Blue Print ADG08645

Hyundai Coupe all models 2001 > Sept 2004

Left hand lower suspension arm modification

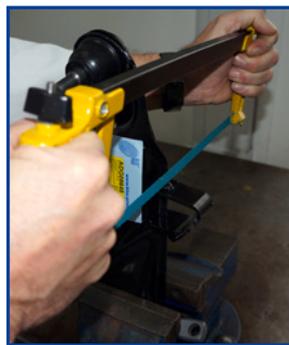
Blue Print follows the same OEM supersession as Hyundai (OEM) on the left front lower suspension arm supplied for the Hyundai Coupe. The arm is fitted with an anti-roll bar bracket which, on the Hyundai Coupe, is not required. Unless this is removed it can interfere with the operation of the suspension. The same situation arises with the original equipment component. This bracket must be removed before the arm is fitted to the vehicle.

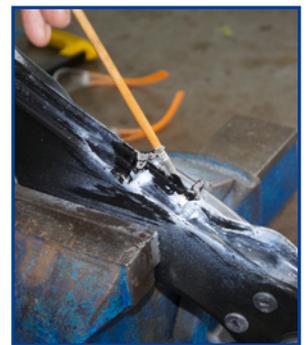
2. Using a hacksaw, cut through the bracket vertically as close to the welded flange as possible.

3. Using a file or hand grinder, remove any burrs or sharp edges.

4. To protect against corrosion it is necessary to cover the exposed bare metal. Apply a layer of primer to the bare metal. Then once dry, apply a coating of an oil based paint. Alternatively use a good quality stone-chip guard type paint.
